## Section 92 Response dated 17 February 2023

Alteration to designation to extend designated area of 9468: Response to s92 for Further Information in relation to Watercare's application D.002350.01.

Request for further information on Notice of Requirement application for relocation of the secondary shaft at 42 Tawariki Street.

## **Appendix A: Updated heavy vehicle tracking**

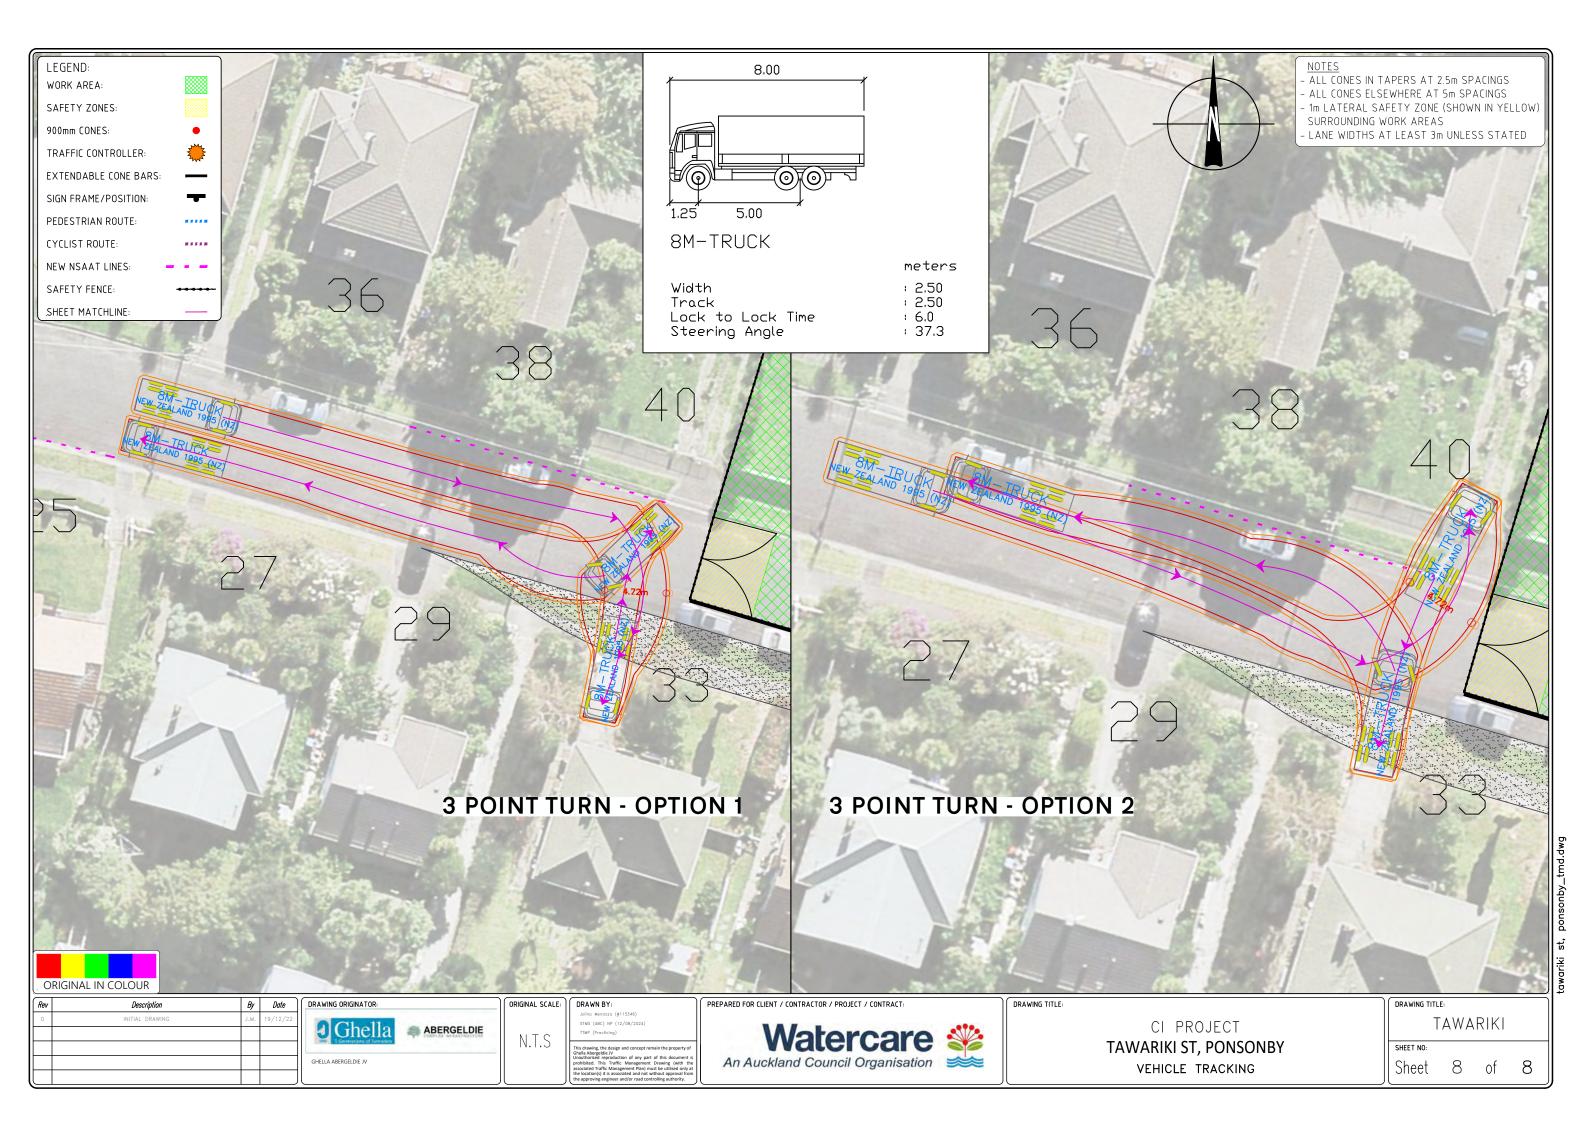
1. Please confirm the properties affected by rubbish collection manoeuvring requiring vehicle crossing reconstruction to a commercial standard based on the alteration to designation. For example, to provide revised rubbish truck tracking based on the designation boundary of the proposed alteration (refer to below extracts from s92 responses). This is not specifically addressed in the AEE. This was noted in AT's initial feedback. It relates to Designation 9468 condition 5.2 (k).

The Tawariki Street terminates in a dead-end, therefore rubbish trucks turn around requires a multi-point turn using residential driveway. During construction, this manoeuvre will be retained for an 8.0 m rubbish truck using 40 and 33 Tawariki Street. A revised vehicle tracking plan has been prepared for rubbish truck manoeuvring and is detailed in Attachment A option 2. The rubbish truck will be required to reverse down the extent of Tawariki Street to service dwellings at 37, 39, and 41 Tawariki Street given this section of Tawariki street will be low speed and minimal traffic, this arrangement is considered acceptable.

## Appendix B: Proposed Residential Property Vehicle access

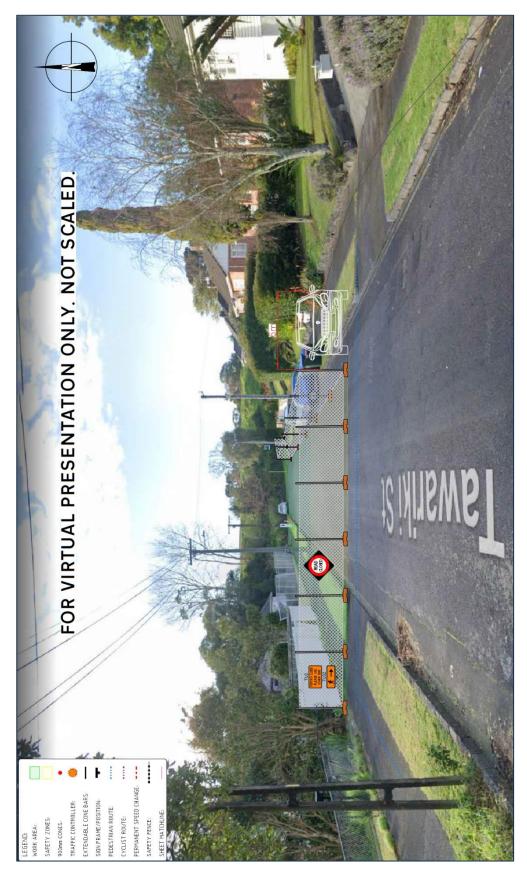
2. Please confirm any changes from the proposal affecting vehicle access servicing private properties and whether access will be maintained during the construction period (in accordance with Designation 9468 condition 5.2(e)).

Vehicle access for residential properties will be maintained during construction. A 6.0 m wide access Right of Way will be built using the existing footpath space adjacent to properties 33-41 Tawariki Street as shown in Appendix B.

# Appendix C: Original parking plan showing the extent of permanent and temporary parking removal

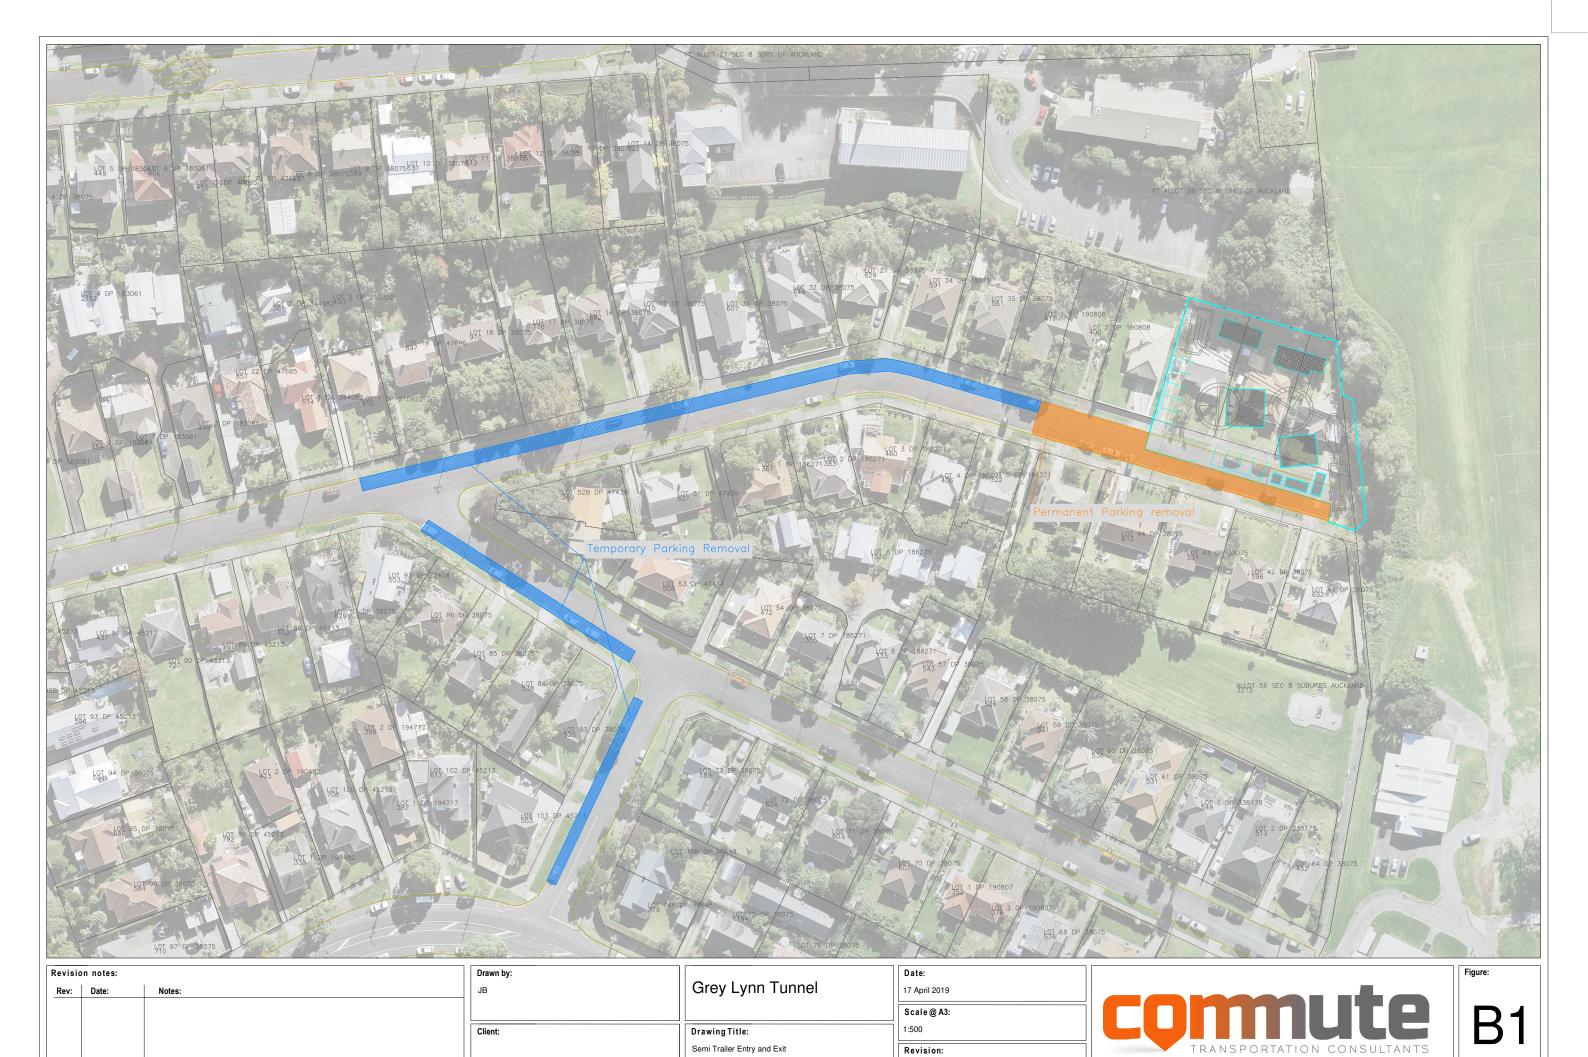
9. In light of the extension to include 42 Tawariki Street, Flow consider that there will be an impact on parking further west and therefore seek that Condition 2.1(o) be amended to include consultation with the property owners of 33, 35 and 37 Tawariki Street as well. It is noted that Kainga Ora are the owners of these properties. You have stated in your request that based on discussions with Kainga Ora they have no concerns with the proposed alteration and will facilitate Watercare's discussions with their tenants. To this end, could you please confirm that the proposed amendment to condition 2.1(o) is acceptable to yourselves and Kainga Ora.

The assessment of this notice to alter Designation 9468 is limited to the change in effects from the alteration. The loss of on-street parking outside 33, 35 and 37 Tawariki Street was assessed and already provided for as part of the original Notice of Requirement. For ease of reference, a Parking Plan<sup>5</sup> showing the extent of permanent and temporary parking removal associated with the already authorised works is attached as Appendix C.

Therefore, an amendment to Condition 2.2 (o)<sup>6</sup> is not necessary. However, the project will continue to communicate with the owners/occupiers of neighbouring properties throughout construction.

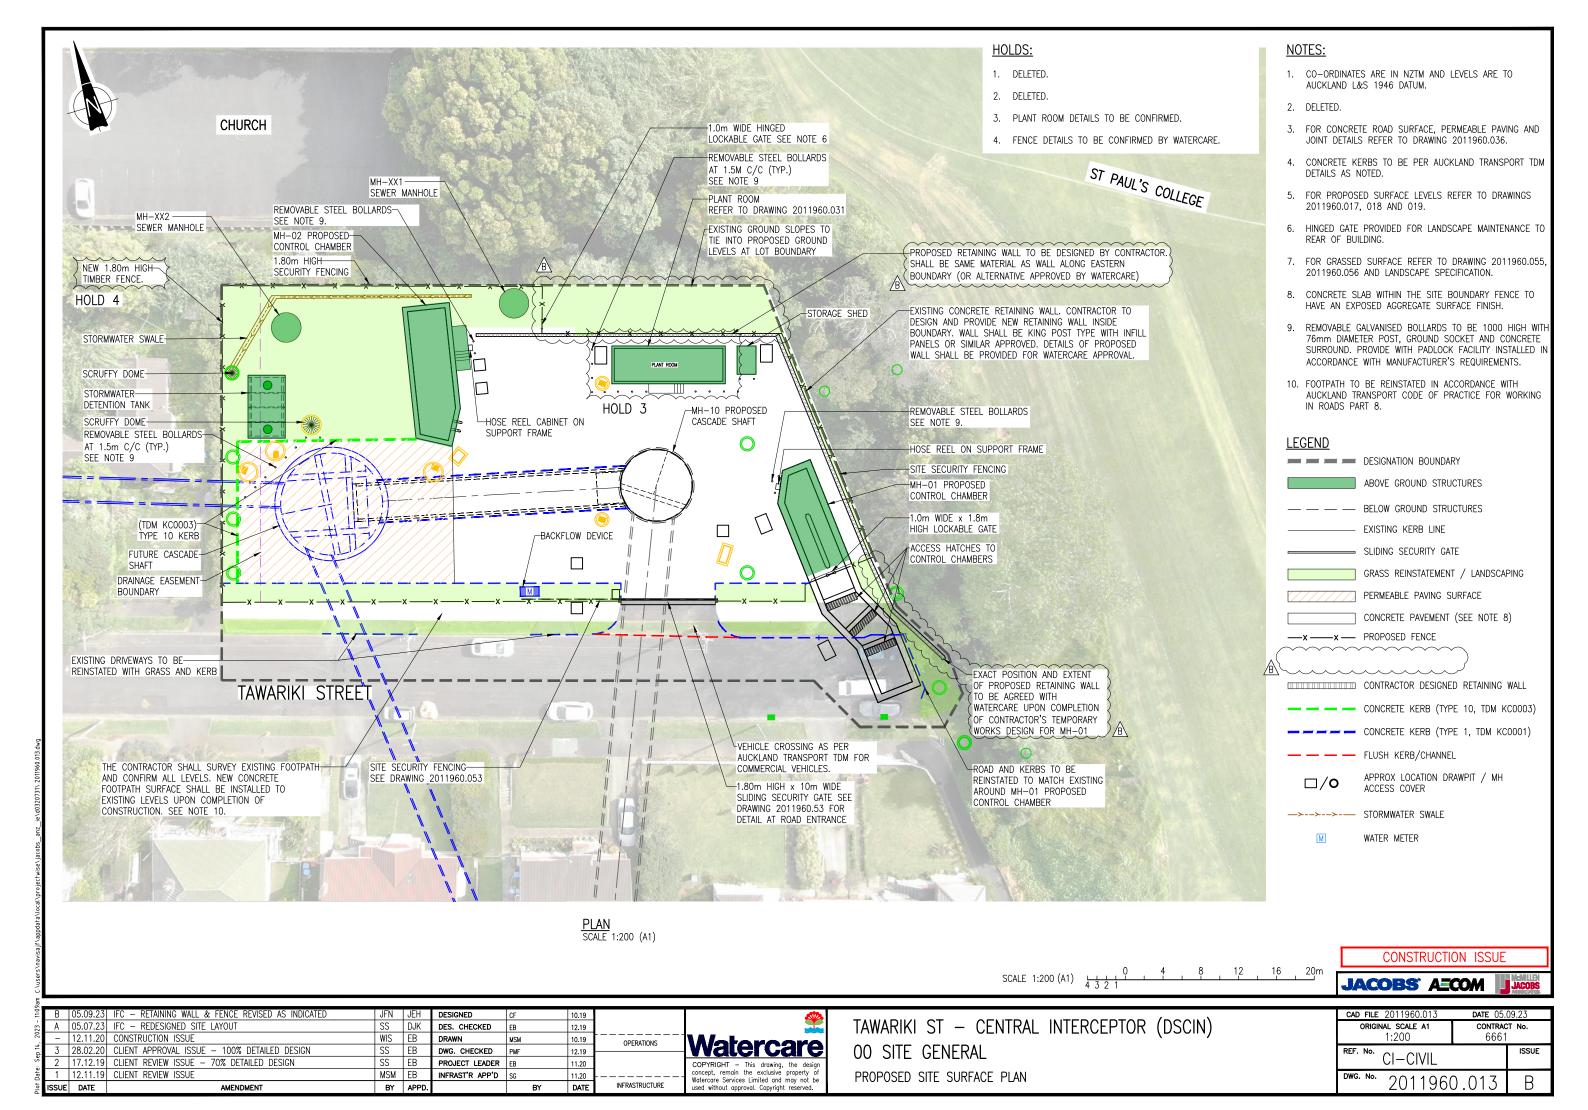
• the full extent of the impervious (concrete) surfaces for the full shaft site (42-48 Tawariki Street) and the on-site detention of the stormwater flows.

The site stormwater will be directed into a new concrete detention tank located on the western side of No. 42 Tawariki Street. The detention tank will be sized to 10 % Annual Exceedance Probability. This will capture stormwater flows from the north (church) and northeast (St Pauls College playground). Upon completion of works, the stormwater detention tank will capture, contain, and convey stormwater across the site and neighbouring properties to either improved or not made worse (2011960.013 B).

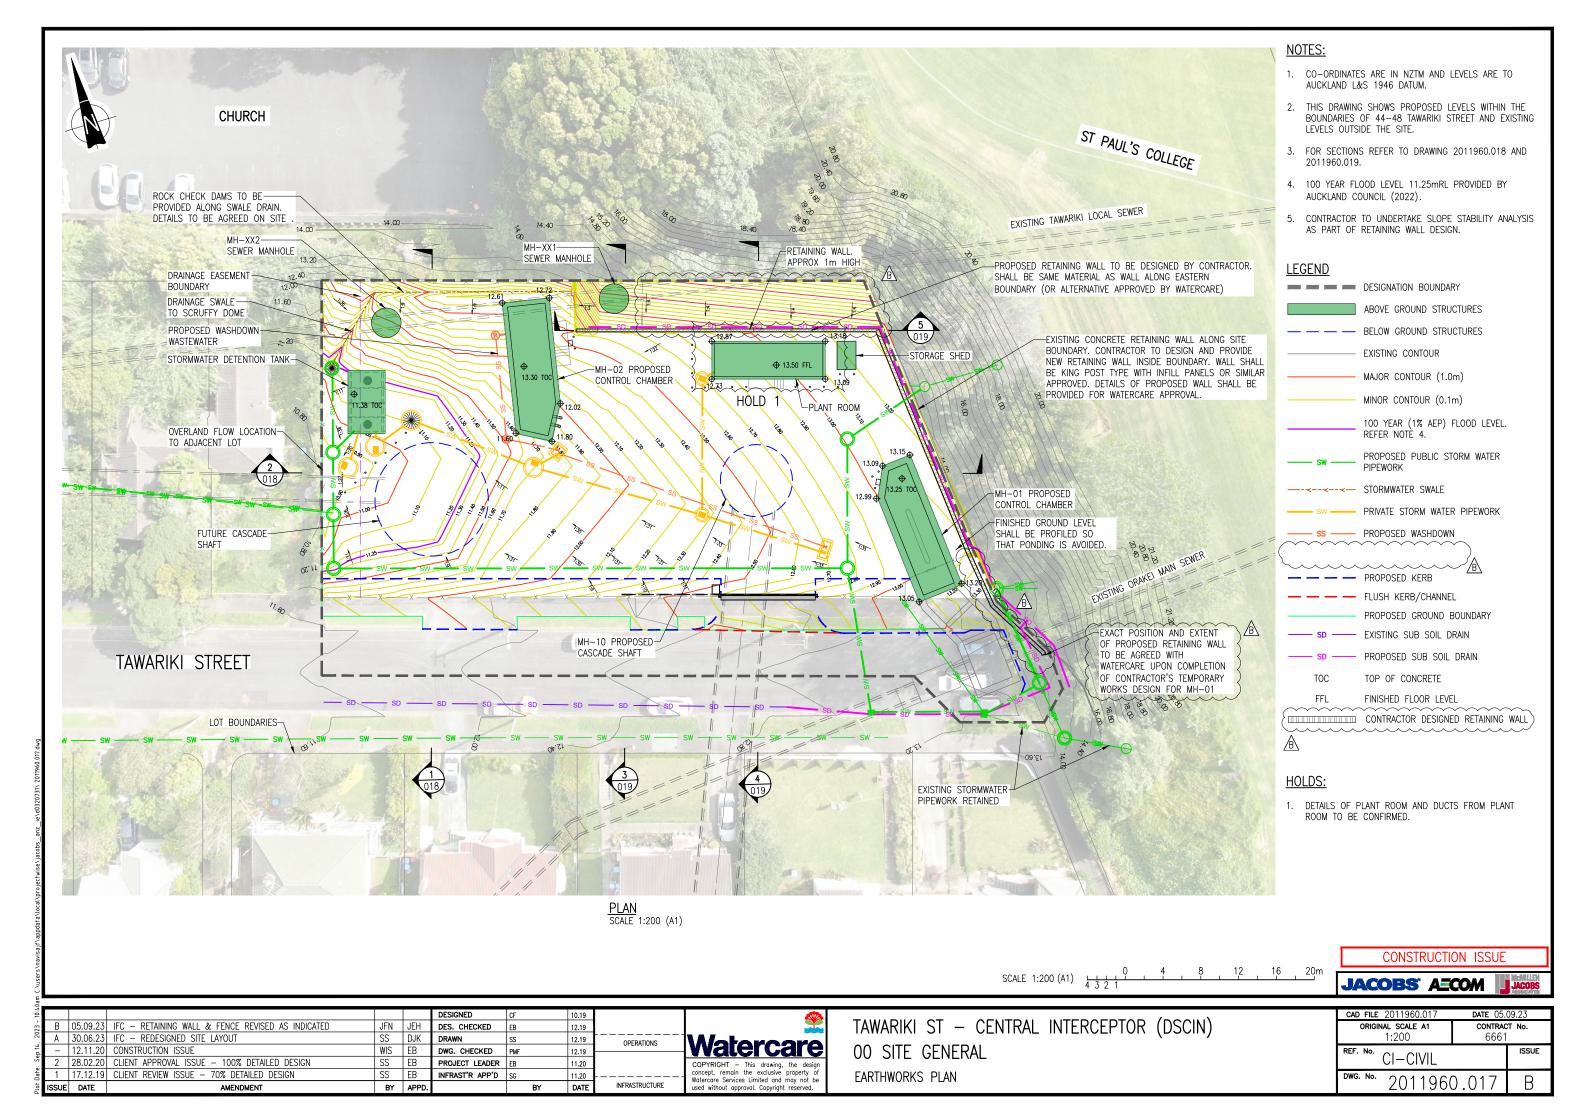
• the displacement of the floodplain over 42 Tawariki Street, particularly how this will be managed to avoid exacerbating any effects on the neighbouring sites downstream

The finished surface will be graded from north and south towards the centre and gently fall from east to west towards the existing low point on the site (flood plain). This will maintain the existing overland flow path on the site and retain capacity of the floodplain. That being said, infrastructure has a functional and operational need to be located in a flood plain. The risks of adverse effects of the permanent structure on other people, property, and the environment is negligible. Drawing 2011960.017\_B final contours
